DEVELOPMENT NO.:	22024855 – Deferred Item Report
APPLICANT:	David Thomson
ADDRESS:	UNIT 2 1-1A FARRELL ST GLENELG SOUTH SA 5045
NATURE OF DEVELOPMENT:	Demolition of existing structures, internal alterations and the construction of single storey dwelling additions with walls located on the western and eastern side boundaries
ZONING INFORMATION:	<p>Zones:</p> <ul style="list-style-type: none"> • Established Neighbourhood <p>Overlays:</p> <ul style="list-style-type: none"> • Airport Building Heights (Regulated) • Affordable Housing • Building Near Airfields • Historic Area • Hazards (Flooding - General) • Prescribed Wells Area • Regulated and Significant Tree • Stormwater Management • Urban Tree Canopy <p>Technical Numeric Variations (TNVs):</p> <ul style="list-style-type: none"> • Maximum Building Height (Metres) • Minimum Site Area • Maximum Building Height (Levels)
LODGEMENT DATE:	22 Jul 2022
RELEVANT AUTHORITY:	Assessment panel at City of Holdfast Bay

CONTENTS:

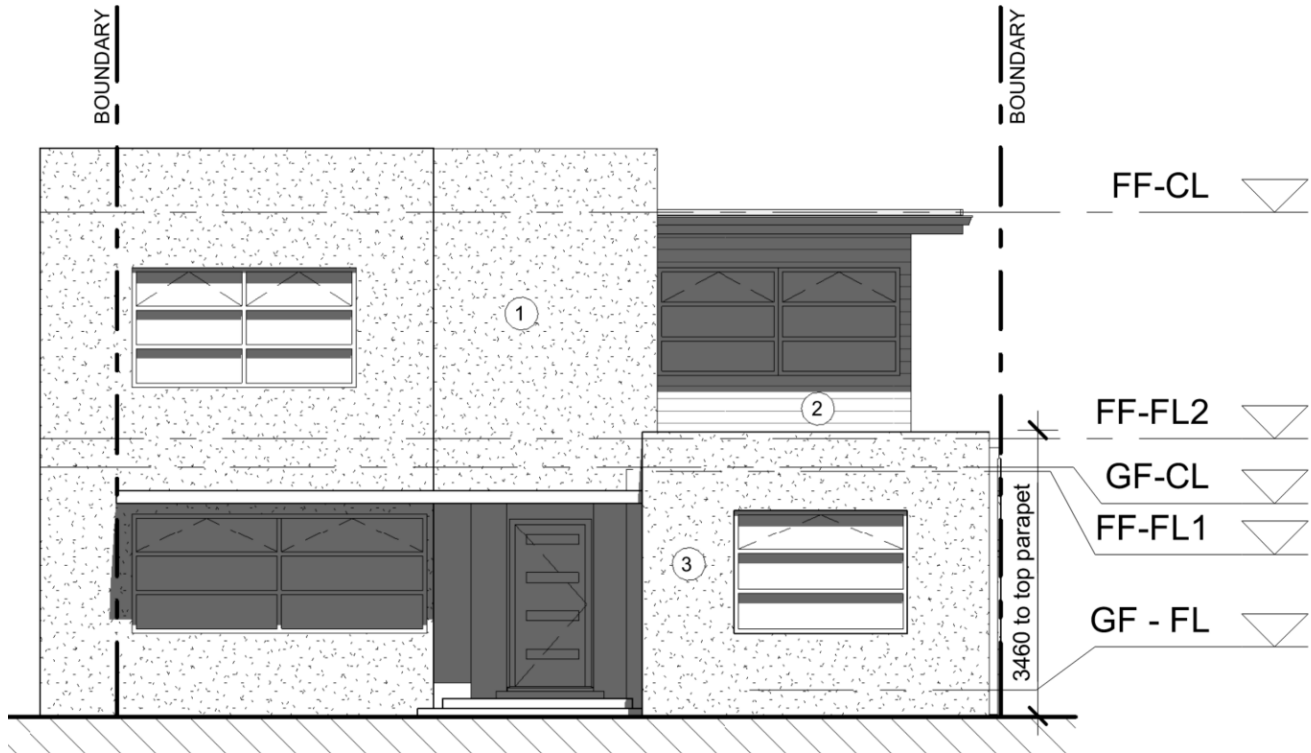
It is recommended that the Council Assessment Panel resolve that Development Application Number 22024855, by David Thomson is deferred for clarity and updated plans regarding retention of the awnings, original architectural features on the front façade and updating the plans to remove the proposed 1.8m high fence shown in the front yard.

1. The rear addition has been reduced in size and will no longer involve construction along the Eastern boundary.
2. The front fence has been omitted from the design.

3. The front façade of the dwelling has been updated to show existing architectural features which are to be retained. Some of these features have been incorporated in other areas of the design for consistency which includes:

- a. The brick plinth to the underside of the existing ground floor window, which will not only be retained but will also be incorporated into the new addition.

- b. The window styles (sliding windows) with vertical mullions will be maintained. This part of the design for the building will be implemented for all new or replacement windows.

- c. The existing awning structures over both the ground floor and first floor windows will be retained as noted on the amended plans.
 - d. The cladding at first floor level (sun room) will be removed and replaced with an energy efficient cladding, which is then rendered and painted to match the rest of the building.

Above: Initial Façade Design

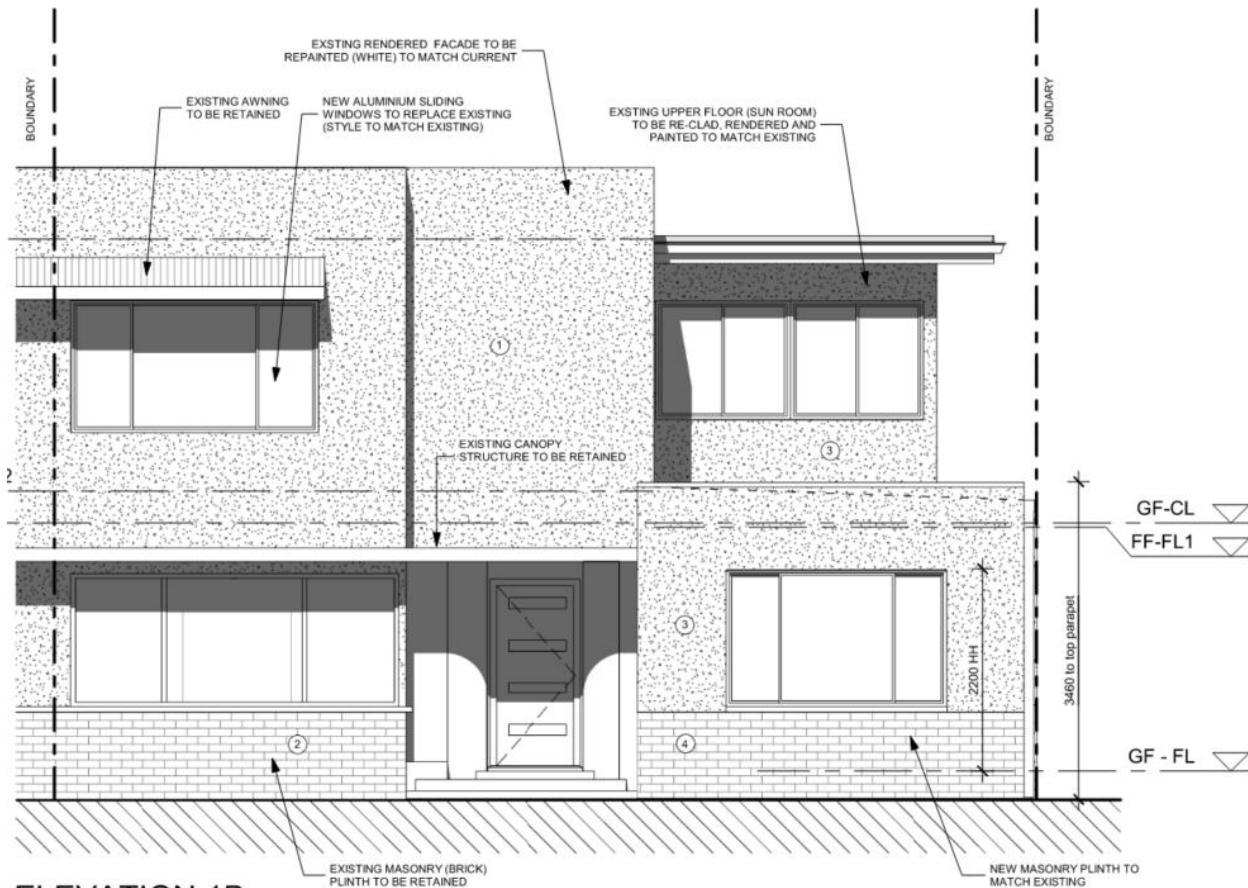
The amended changes to the façade of the dwelling will see little change to the overall appearance of the dwelling in its current form. The retention of the awning over the upper-level window, the existing canopy, window designs and the existing masonry plinth are elements that currently contribute to the streetscape character. The inclusion of the masonry plinth to the addition provides continuity and consistency to the lower building level. It also plays a role in breaking up the rendered façade of the addition.

Below is the original and amended façade design which shows a clear difference in the dwellings appearance.

The application in its amended form now better aligns itself with the Historic Area Overlay Assessment Provisions listed below:
